Reply to Referee #2 (Dr. F. Wienhold)

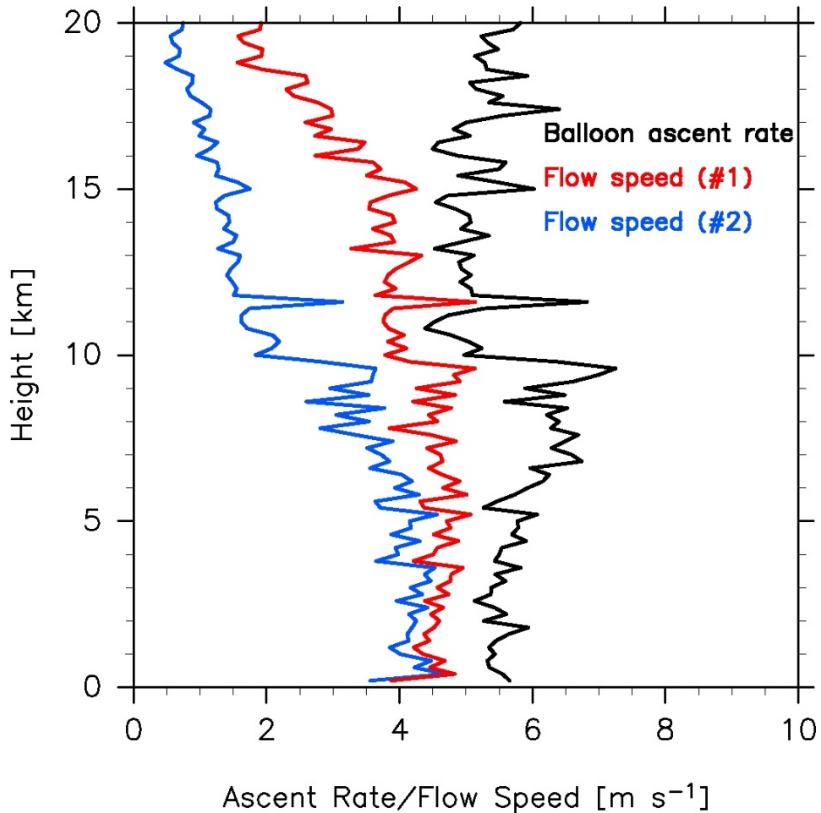
The air flow speed in the instrument is essential both to convert the count rate into number density, and to correct for signal overlap caused by multiple particle detection. Substantial flow speed reduction with respect to the ascent rate is reported for the instrument geometry used, rough agreement is found only for larger cross sections tested. Equating the flow speed with the typical sounding balloon ascent rate of 5 m/s – with a resulting reference signal width of 1 ms – is inappropriate when the effects number density conversion and overlap correction are not discussed (see also specific comments). Low number density regions near ground in Figures 5 and 7 with signal widths in excess of 1 ms conflict the undiminished flow assumption. The corrected particle count rate should be clearly addressed as an upper bound estimate, not just as corrected value.

First, in the revised manuscript, we will add a new appendix, Appendix B where we will show the results from a CPS with two hot-wire anemometers (with the uncertainty of $+/-1$ m s^{-1} ($k = 2$)) launched at Moriya at 17:11:47 LT on 23 November 2012 (see Figure R1-2). The two hot-wire anemometers were placed within a 6-cm long duct (with a similar inner cross section to that of the CPS's air inlet), near the two openings, and this duct was attached at the bottom side of a CPS. Thus, the anemometer #1 is located \sim 4 cm below the detection area, and the anemometer #2 is 9–10 cm below the detection area. Figure R1-2 compares the balloon ascent rate and the flow speed in the duct measured with two anemometers. From the surface up to \sim 10 km, the balloon ascent rate is 5–6 m s^{-1} , flow speed measured by the anemometer #1 is 4–5 m s^{-1} , and flow speed for #2 is 3–4 m s^{-1} , with increasing discrepancy between #1 and #2 at higher altitudes. Between 10 and 16 km, the balloon ascent rate is \sim 5 m s^{-1} , flow speed for #1 is \sim 4 m s^{-1} , and flow speed for #2 is 1–2 m s^{-1} . It is expected that the actual flow speed for #1 and #2 would not differ because of the same cross section of the air flow. However, the measurement results show that this was not the case. Possible reasons include the horizontal difference in the flow speed within the duct and in the location of the two anemometers (i.e. the anemometer #2 may have been located closer to the duct wall during the flight). Also, these anemometers might have had some directivity dependence, which had not been evaluated in the laboratory experiments. Considering the additional flow of up to 2 m s^{-1} due to the pendulum motions, assumption of a constant flow speed of 5 m s^{-1} with the uncertainty of a factor of \sim 2 (as the contribution from the flow-speed assumption) is not unreasonable.

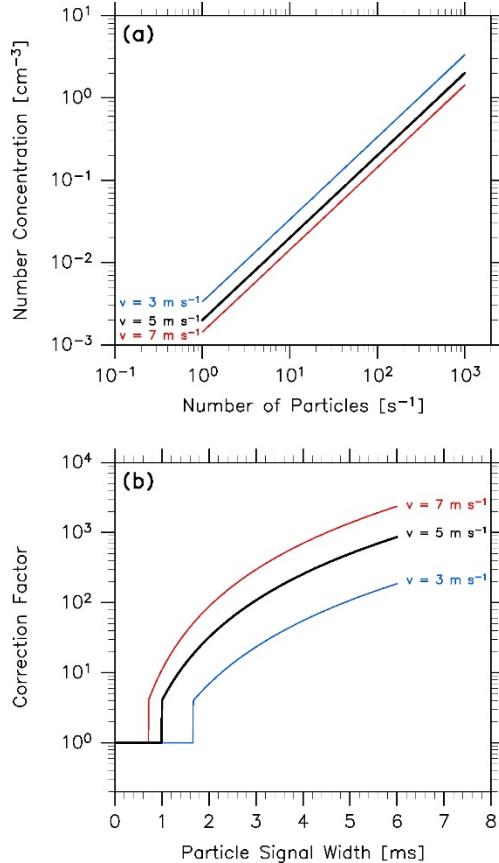
Page 6, line 27: The signal width factor f enters the count rate correction to the third power. An assessment of the consequences should be provided.

Second, in the revised manuscript we will have a new appendix, Appendix C where we discuss the impact of different flow speeds on the number density conversion and the count number correction (see the next paragraph and Figure R2-2). In this way, the uncertainty in the number concentration values from the CPS is better understood, and the future CPS users can use this information to process and evaluate their data.

Both the conversion from number of particles N [s^{-1}] to number concentration C [cm^{-3}] and the correction factor for N depend on the flow speed within the detection area v [$m s^{-1}$]. As the cross section of the detection area is $\sim 1 cm^2$, C is given by $N/(100v)$. As the vertical extent of the detection area is ~ 0.5 cm, the correction factor for N (see discussion in Sect. 2.3) is $4 \times (psw/(5/v))^3$ if psw is greater than $5/v$, where psw is particle signal width in ms; if psw is smaller than $5/v$, the correction factor is unity. Figure C1 shows the relationships between N and C and between psw and the correction

factor for $v = 3, 5$, and 7 m s^{-1} . This indicates the contribution of the uncertainty in v (see also Appendix B) to the uncertainty in (corrected) N .
